Proposed Solar Power Station on Land West of Boxted, Suffolk

Landscape & Visual Review

by Carly Tinkler BA CMLI FRSA MIALE
for Save Glem Valley
February 2024

Proposed point of access to site

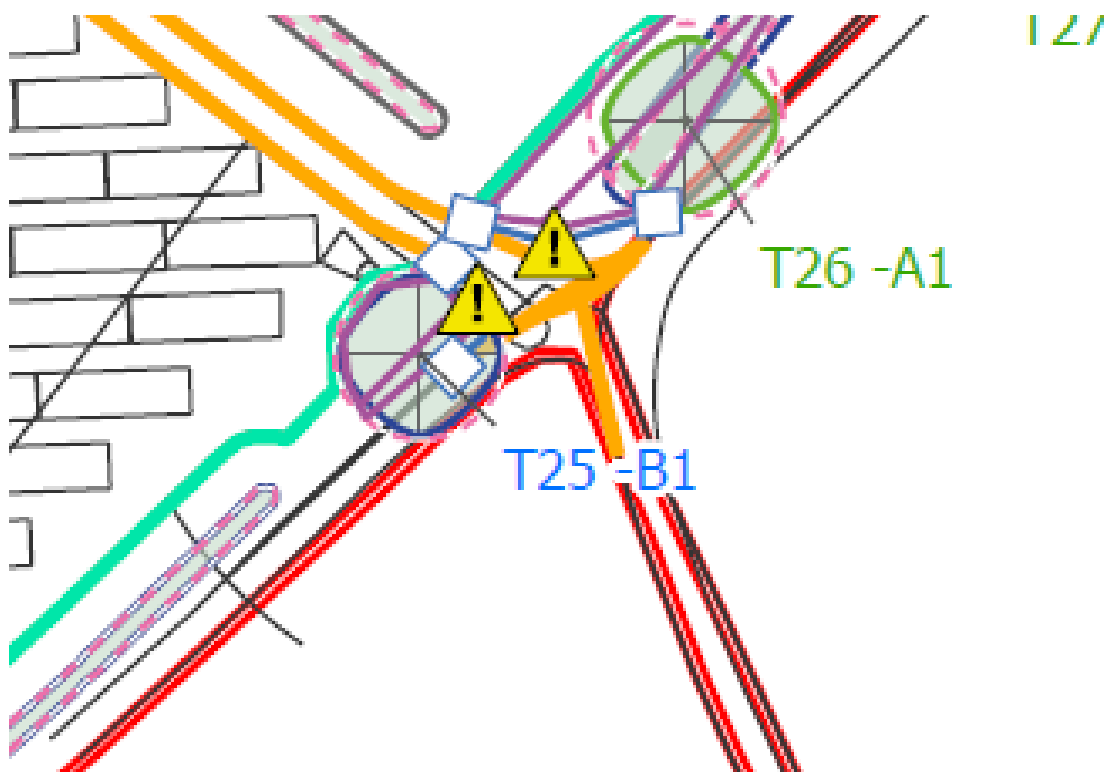
5.3.28 Of particular concern is the urbanisation of this deeply rural and very beautiful spot that would occur through the loss of high-value mature vegetation, and the introduction of long lengths of tarmac / other hard surfacing; concrete kerbs; metal gates and fencing; warning signs; lighting; CCTV; and so on (see Applicant's / other plans, for example *Swept Path Analysis of a 18.55m Articulated Vehicle* (drawing no. P21-2950-SK02 (Draft)), *Proposed Site Access Arrangement* (drawing no. P21-2950 SK01 (Draft)), and SCC's standard *Industrial and Farm Access Layout* (drawing no. DM04 Rev B)).

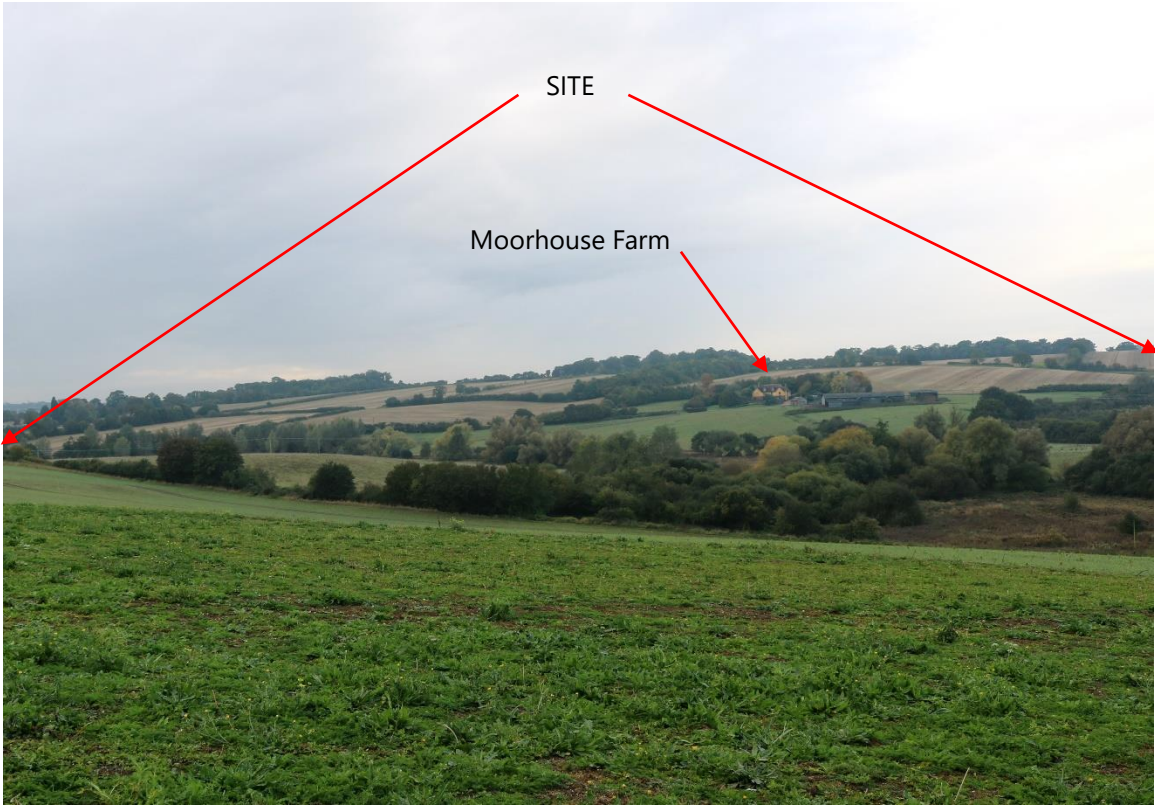
8.3.13 The LVA concludes that *'there is some potential for views from the south facing aspects of the property and its surrounding curtilage'*. It estimates that between Years 1 and 6, levels of effects would be **Moderate Negative, reducing to Moderate / Minor Negative between Years 7 and 40**.

8.3.14 I did visit the property, and agree with the LVA that currently, mature vegetation in the gardens screens or filters certain views of the site. However, the same factors outlined above for VP1 apply to this VP. Also:

- i) The site is clearly visible from several aspects of the property, not just south-facing. It is also visible from both ground level, and upper floors (see photos below).

View from proposed site access point looking north towards south-facing River Glem valley slopes

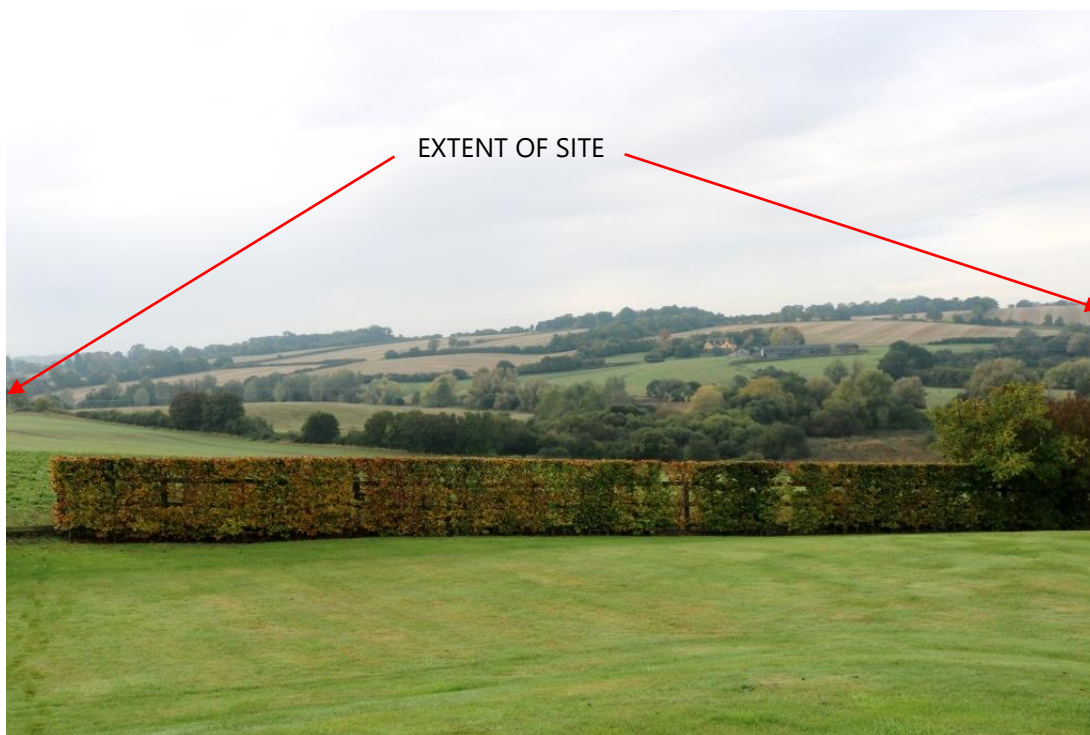
8.3.16 The affected properties, which are quite scattered, lie north of Boxted on the south-facing River Glem valley mid-slopes, opposite the site, between c. 400 and 800m from the site's north-eastern boundary, on both sides of the B1066. The views from these properties are represented by LVA VPs 7 and 10, and a photomontage of the developed view was provided for each.

8.3.17 The same or similar factors outlined above for VP1 apply to these VPs as well. The most important points to emphasise in this case are:
